Request for Class II Permissive Change(C2PC)

FCC ID: VG8EM025FXXXV2

This is a C2PC application for which the previous grant was issued on 2020-07-07.

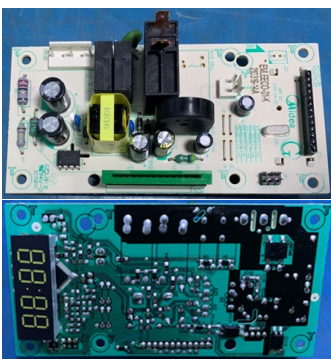
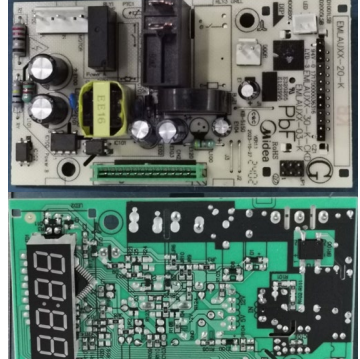
1. Difference in appearance & construction & PCB:

No.:	Original	New	Difference(s)
1	 <p>Original keypad image showing various cooking functions and a color-coded legend: Black, Pantone cool Gray 6C, Pantone 199c, Pantone 299c.</p>	 <p>New keypad image showing the same functions as the original, but with a note: "半透明烟灰色视窗, 透光度: 14% ± 4%" (Semi-transparent smoke gray window, light transmittance: 14% ± 4%). The legend is also present.</p>	<p>Keypad: Updated front keypad to accommodate child lock function (Child resistant oven door function).</p>
2	 <p>Original motherboard image showing the internal circuitry.</p>	 <p>New motherboard image showing the internal circuitry with modifications.</p>	<p>Mother board: Modified the peripheral circuit (non-RF circuit) and some individual components and PCB layout. The magnetron and other circuit are exactly same as before.</p>
3	Not Applicable	 <p>Image showing the solenoid valve locking mechanism.</p>	<p>The new one adds a solenoid valve locking mechanism, the original is not.</p>
